**PORT TOWNSEND HEARING EXAMINER
PUBLIC HEARING AGENDA
CITY HALL COUNCIL CHAMBERS, 540 WATER STREET**

- A. LUP22-019 Preliminary Plat and Plat Alteration- The Plat of Pods at the Vineyards**
1. Staff Report
 2. Testimony by the Applicant
 3. Public Testimony
 4. Rebuttals
 5. Hearing Examiner Summary

1. Davos Capital LLC, with partners Steve and Ann Raab (collectively “Applicant”), have submitted application for a preliminary Plat with Plat Alteration (“Plat”) named *Pods at the Vineyard* (“PAV”) (Exhibit A – *Preliminary Plat application with cover letter, rain garden and prairie habitat source material, and revised Plat/Plat Alteration map*; Exhibit B – Site Plan, Shts. 1-4 including Tree Conservation and Landscaping, subject *property deeds, topographic survey map*; Exhibit C - Revised Preliminary Civil Plans, dated Jan. 17, 2024; and, Exhibit D – Revised Stormwater Plan and Report, dated Jan. 17, 2024. PAV creates 17-lots for detached residential development over roughly three (3) + acres. One (1) lot at PAV already contains an existing single-family residence. The property’s current legal description is on pg. 1, above, and in the deeds of Ex. B to this staff report.

**PODS AT THE VINEYARD
 PROPOSED SEWER & WATER LAYOUT
 MARCH 1, 2022**

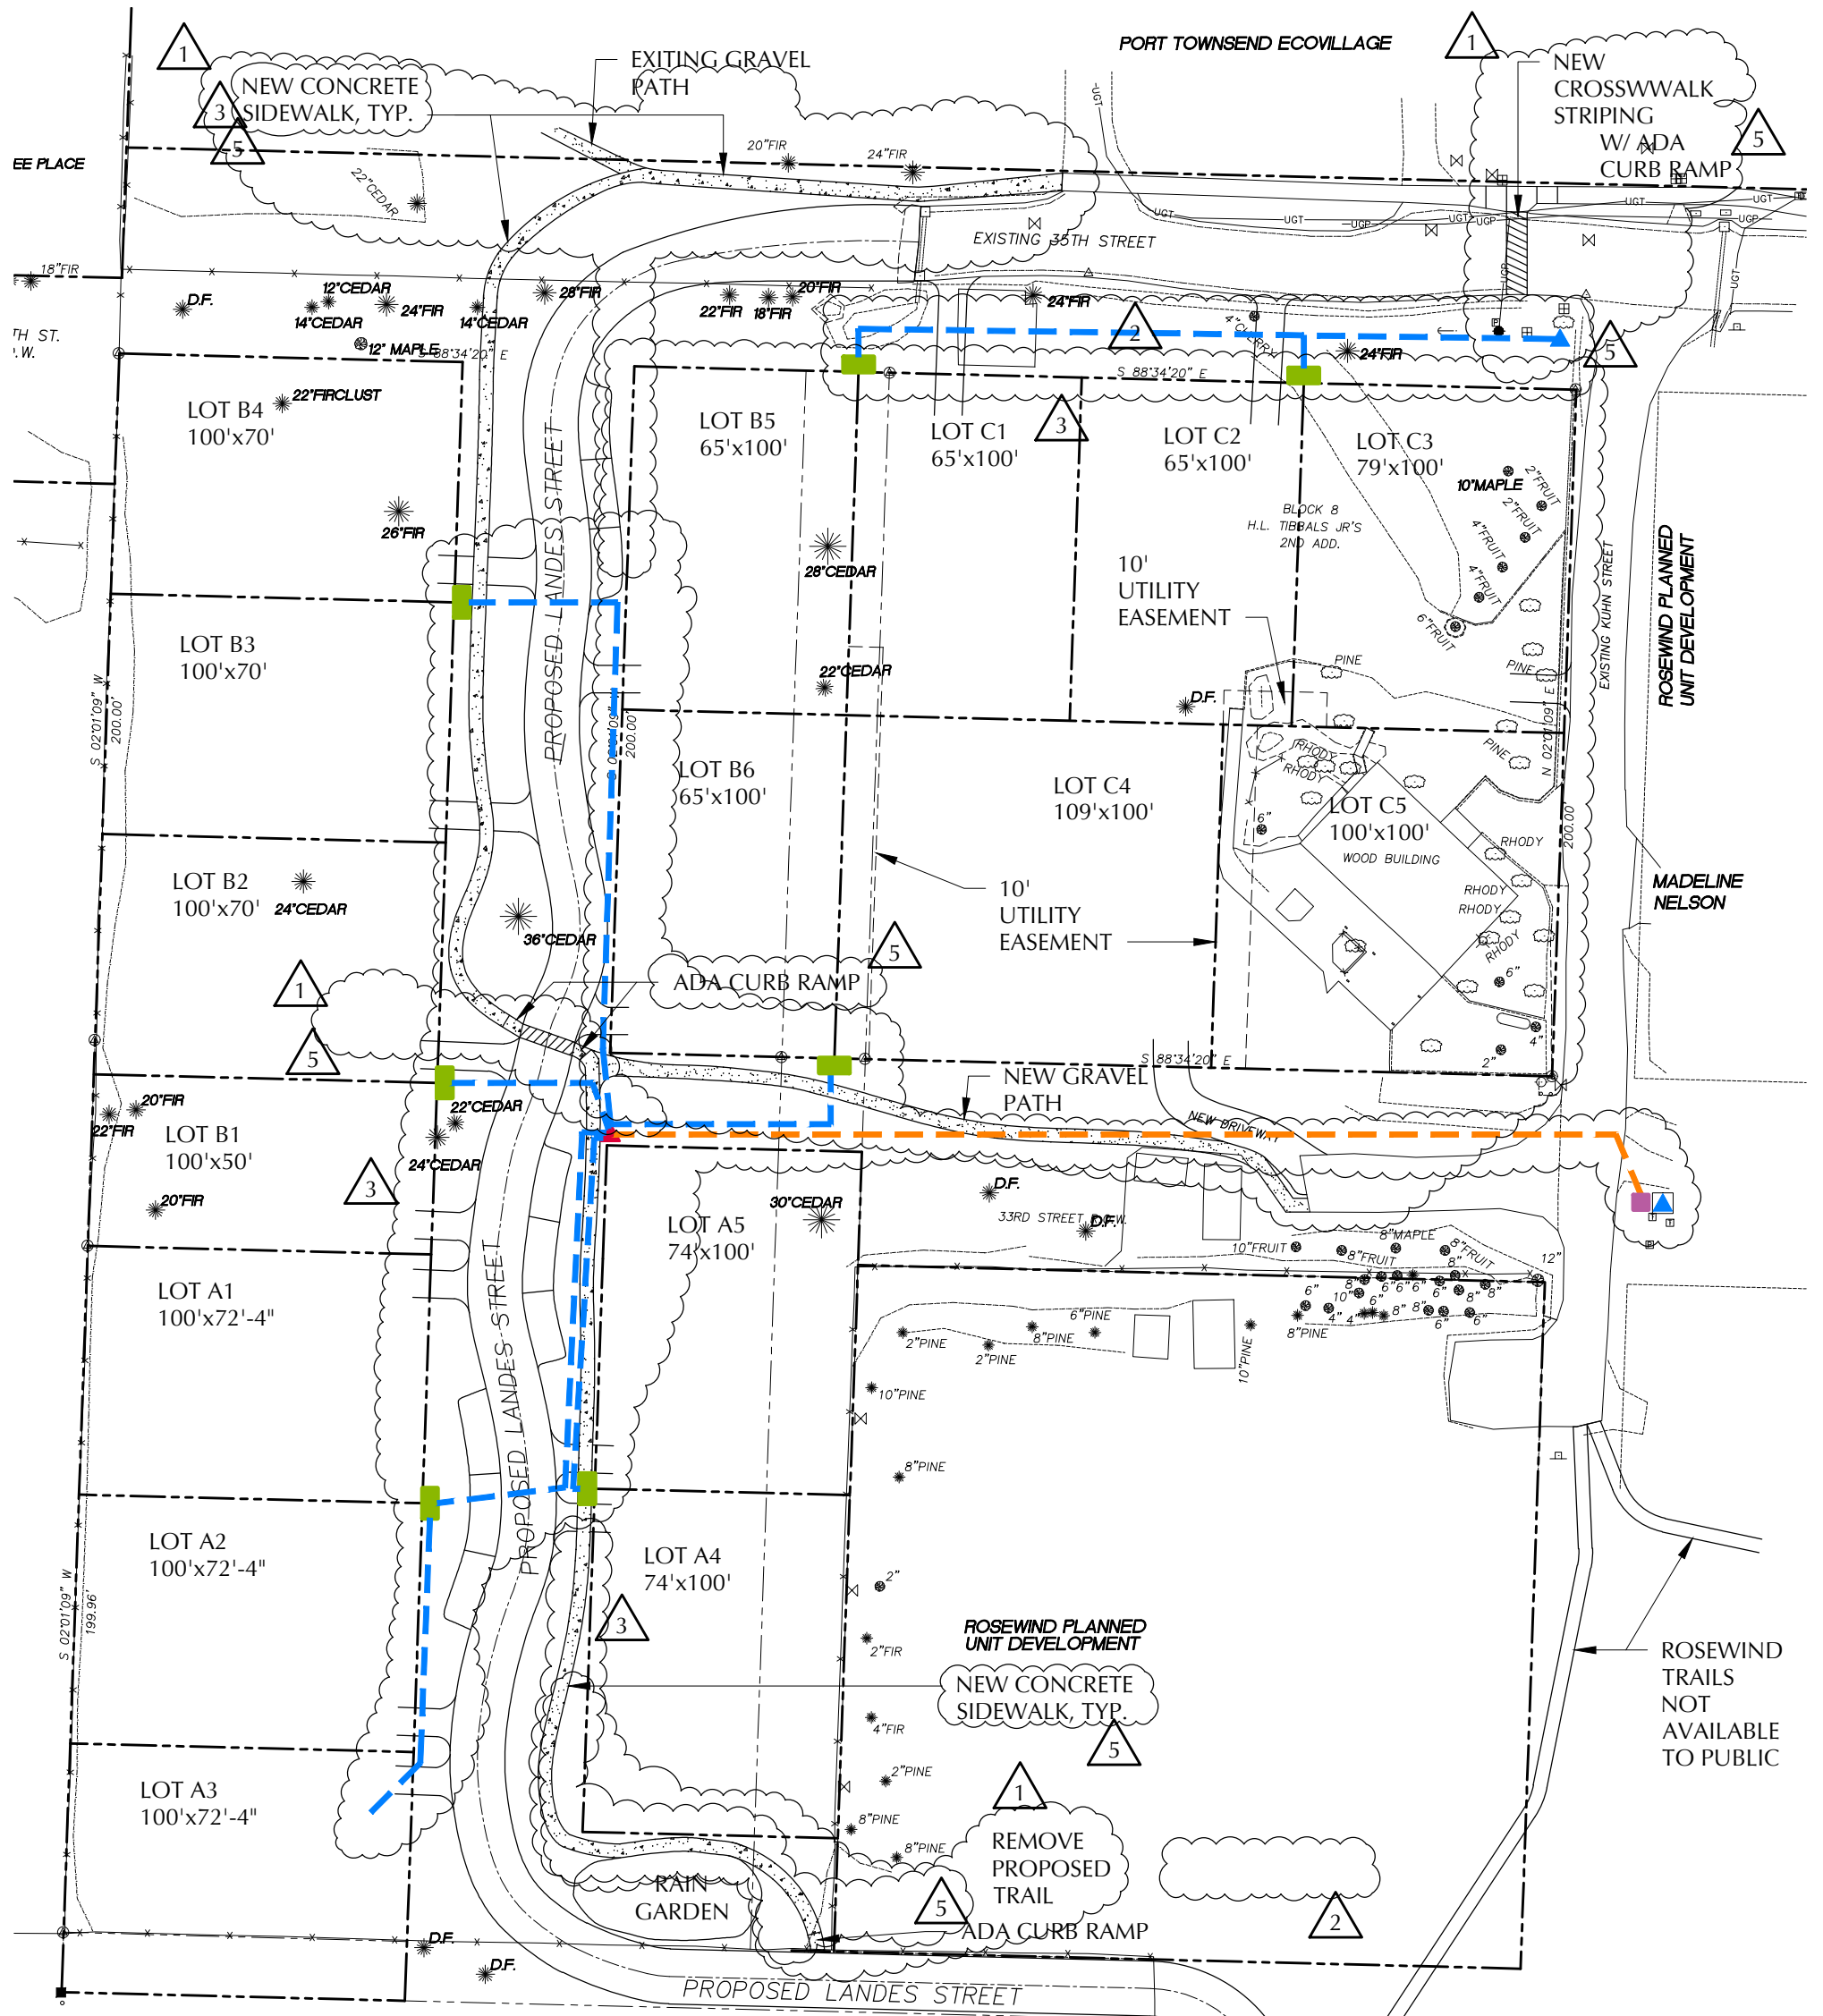
- t. PAVT's "PROPOSED SEWER & WATER LAYOUT" Sheet 2, stamped and signed by Richard Berg, principal architect with Terrapin Architecture PC, shows the proposed pressurized sewer line to run extremely near or through the Critical Root Zone of two (2) existing trees – a 36" Cedar between Lot B2 and Lot B7) and a 28" Fir near the proposed north cleanout in the 35th St ROW.

- v. PAVT's "PROPOSED SEWER & WATER LAYOUT" Sheet 2 shows the proposed new water line to run extremely near or through the Critical Root Zone of the 22" Cedar just east of Lot B1 at the tee of the proposed waterline.

- 13) Per the title reports, there are not easements that affect the site.
 - 15) Sizes and invert elevations of the sanitary sewer lines that are affected by this development are shown on the Utility plan, Sheet 2, and on the preliminary civil plans.

- 17) Water system facilities and proposed fire hydrant are shown on the Utility Plan, Sheet 2.
 - 19) Existing and proposed trees are shown on the Landscape Plan, Sheet 4.

PODS AT THE VINEYARD
PRELIMINARY POWER/CABLE LAYOUT
MARCH 1, 2022

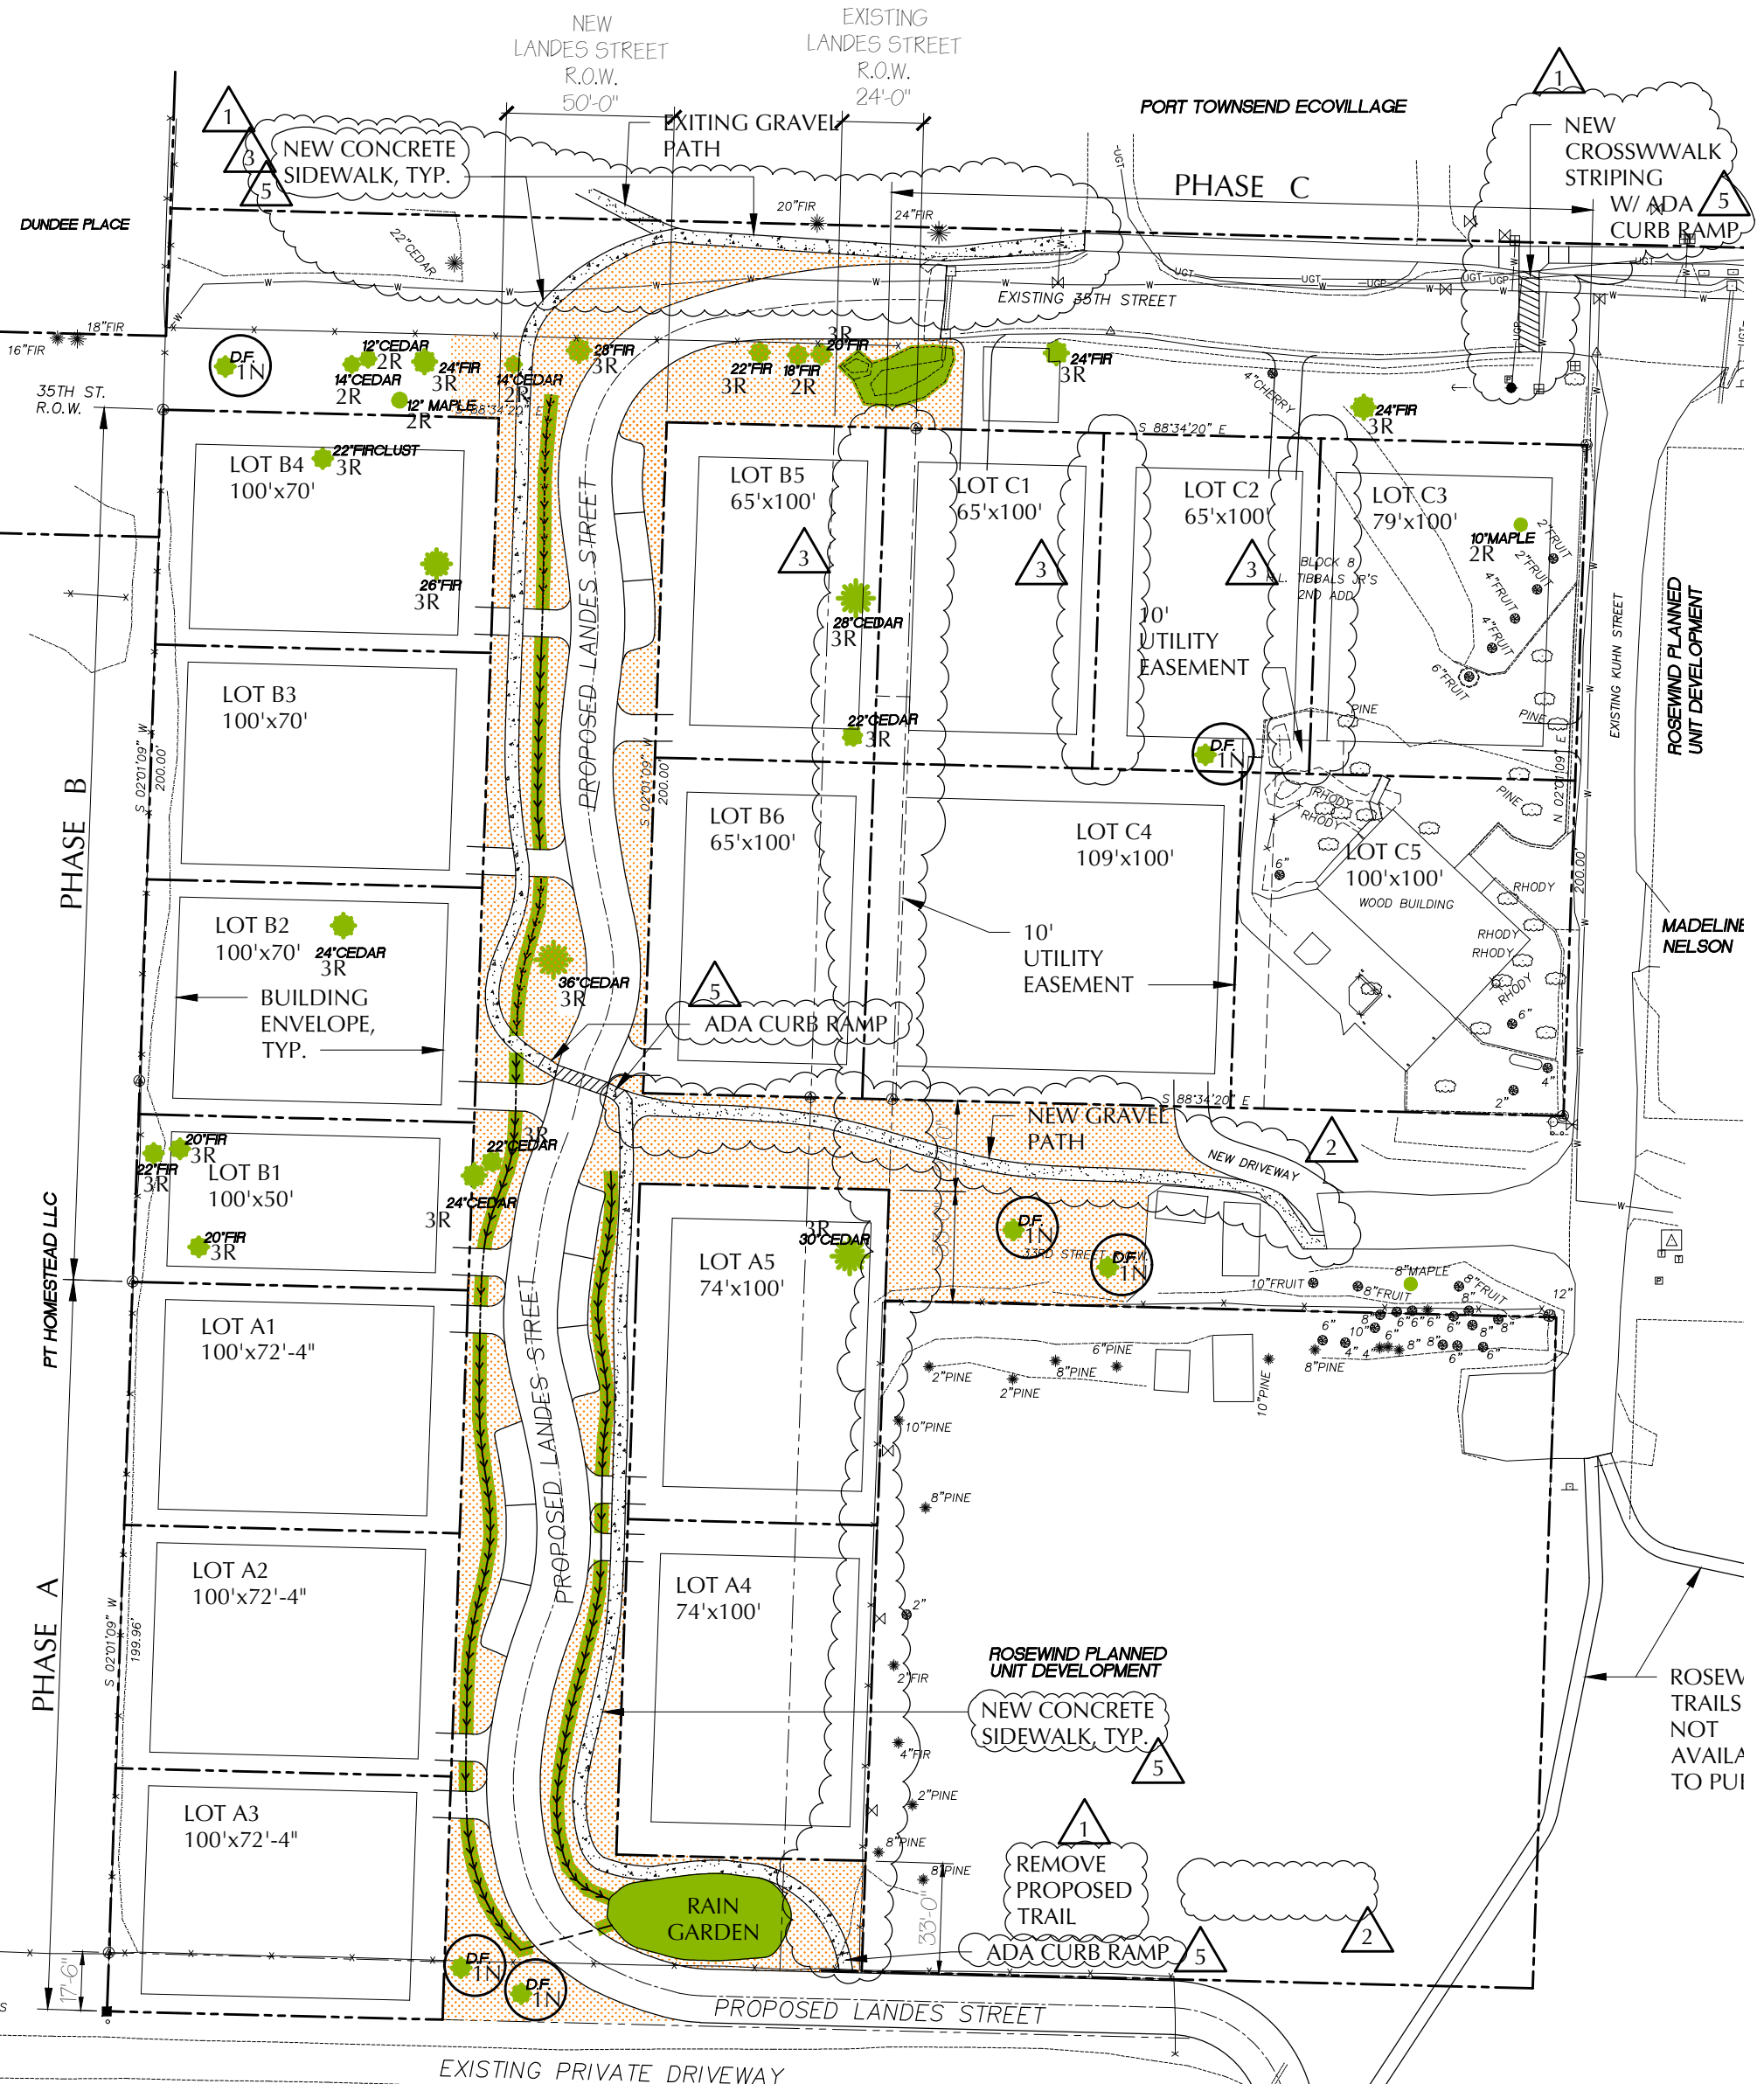
14. Sheet 3 "Preliminary Power/Cable Layout" – this sheet indicates two new Transformers in the 33rd Street ROW, north of Lot A5, that will deliver power to all but 4 of the new lots. However, the plans do not identify the electrical power extensions necessary to those two new transformers.

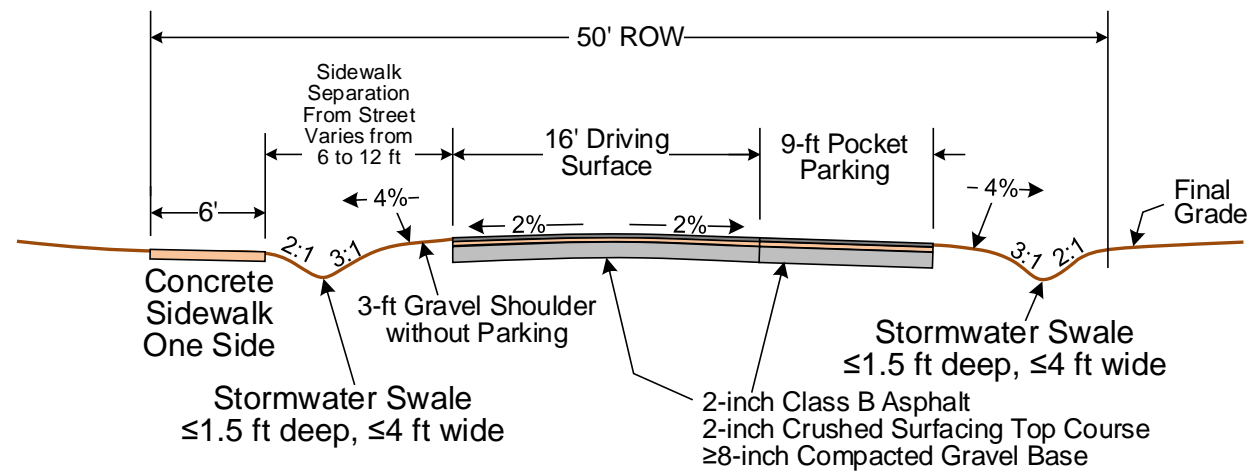
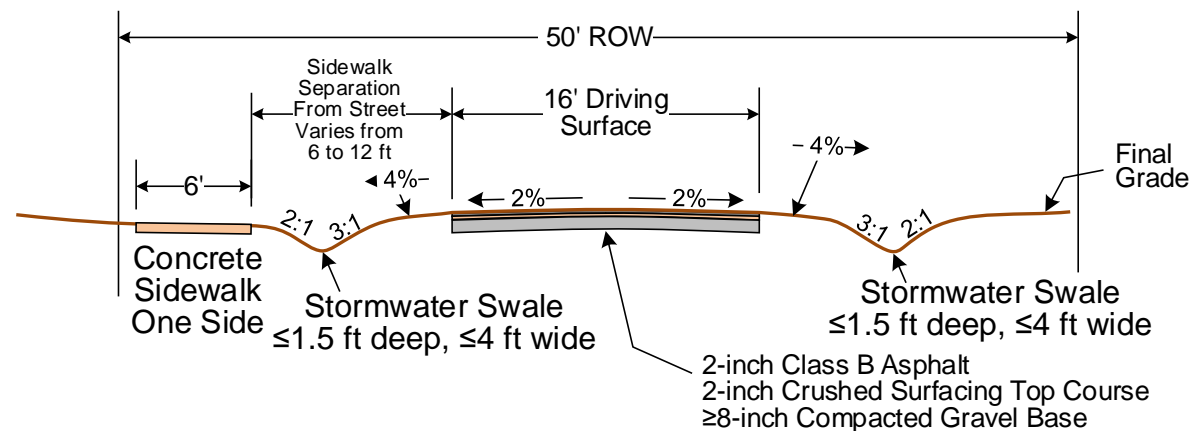
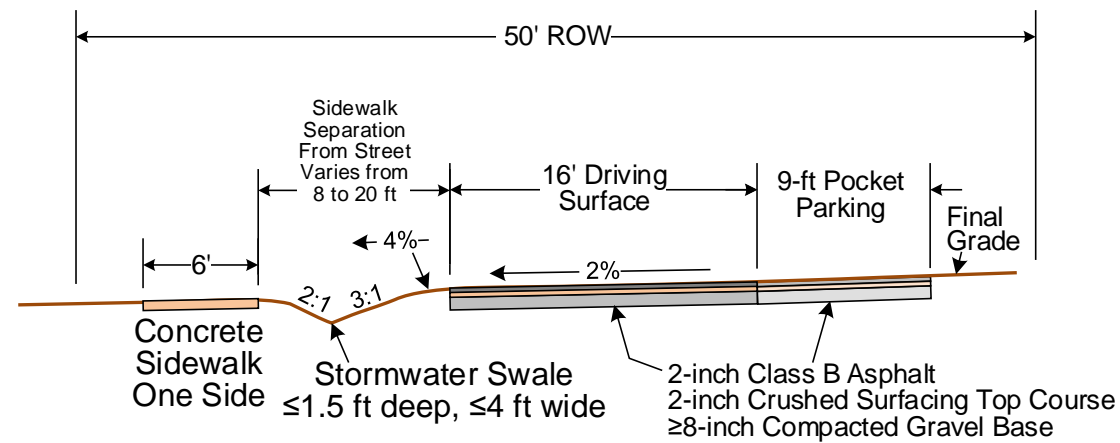
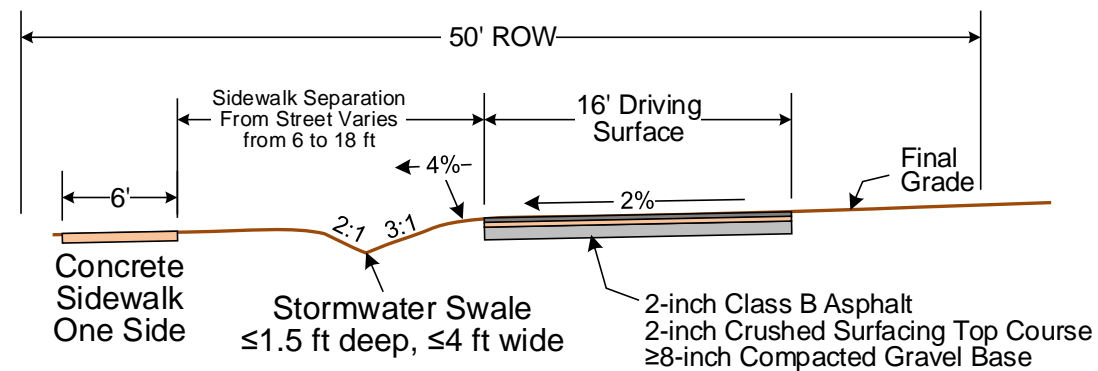
- a. Why does the Civil Engineering sheet C2 provide details for Modified T-6 when the applicant's letter states that they are proposing a T-9 street for vehicular and bike traffic?
- b. What sections of the proposed Landes Street are to be T-9 (as stated in the March 3 2022 letter) if any, and where are the corresponding engineering details for the T-9 section?
- c. Why does the PAV plans not conform to the City's review statement that the road section to be built will be a T-8, when the plat/plat alteration plans are essentially the same design as was reviewed by the City during the pre-app process in 2021?
- d. How am I, or anyone else, supposed to comment on the proposed road having different t types of streets proposed but no definitive plans to review?

2. Conflicting Street Design Standards and Details – Civil Engineering Sheet C-2

Civil Engineering Sheet C2 shows a 16-foot paved driving surface, rather than the minimum 22-foot. The proposed street details are nonconforming to the T-6 design standards.

- b. PATV's "Pods at the Vineyard Civil Engineering Sheet C2" drawn, stamped and signed by Everett A. Sorrensen, P.E., states "Proposed Street Sections: Modified Public Works **Street Standard T-6**". Each of the four street sections drawn on Sheet C2 state "Modified PW **Std T-6** for Local Access".

- c. In five (5) places on the Civil Engineering Sheet C2 the proposed Landes Street is incorrectly identified as a modified street standard T-6.
 - d. On Sheet 1 of the "Greenpod Development" plans, stamped and signed by Richard Berg, principal architect with Terrapin Architecture PC, the proposed Landes Street has four cross sections labeled "A", "B", "C" and "D". Cross section "A" is located between Lot B4 and Lot B5; cross section "B" is located between Lot B3 and Lot B6; cross section "C" is located between Lot A1 and Lot A5; cross section "D" is located between Lot A3 and Lot A4.

- e. PATV's Civil Engineering Sheet C2 contains details for four street cross sections labeled "A", "B", "C" and "D".
 - f. Typically, each of these labeled street cross section details would correspond to the associated labeled sections on Sheet 1 of the site plan.

- g. The street section detail drawn and labeled "A" on Sheet C2 **is not an accurate drawing** of the section of Landes Street drawn and labeled "A" on Sheet 1 of the Greenpod Development site plan. The section detail on Sheet C2 shows two stormwater swales whereas the site plan Sheet 1 only shows one stormwater swale.

- h. The street section detail drawn and labeled "B" on Sheet C2 **is not an accurate drawing** of the section of Landes Street drawn and labeled "B" on Sheet 1 of the Greenpod Development site plan. The section detail on Sheet C2 shows two stormwater swales whereas the site plan Sheet 1 only shows one stormwater swale.

- i. The street section detail drawn and labeled "C" on Sheet C2 **is not an accurate drawing** of the section of Landes Street drawn and labeled "C" on Sheet 1 of the Greenpod Development site plan. The section detail on Sheet C2 only shows one stormwater swale whereas the site plan Sheet 1 shows two stormwater swales.

- j. Additionally, the section detail drawn and labeled "C" on Sheet C2 shows a 6' pathway on the west side of the street whereas the site plan Sheet 1 shows the pathway on the east side.

- k. The street section detail drawn and labeled "D" on Sheet C2 **is not an accurate drawing** of the section of Landes Street drawn and labeled "D" on Sheet 1 of the Greenpod Development site

- plans. The section detail on Sheet C2 only shows one stormwater swale whereas the site plan Sheet 1 shows two stormwater swales.
- l. Additionally, the section detail drawn and labeled “D” on Sheet C2 shows a 6’ pathway on the west side of the street whereas the site plan Sheet 1 shows the pathway on the east side.

- m. None of the four street section details drawn by the professional engineer on Sheet C2 are accurate drawings of the corresponding sections of Landes Street on Sheet 1 of the Greenpod Development site plans.
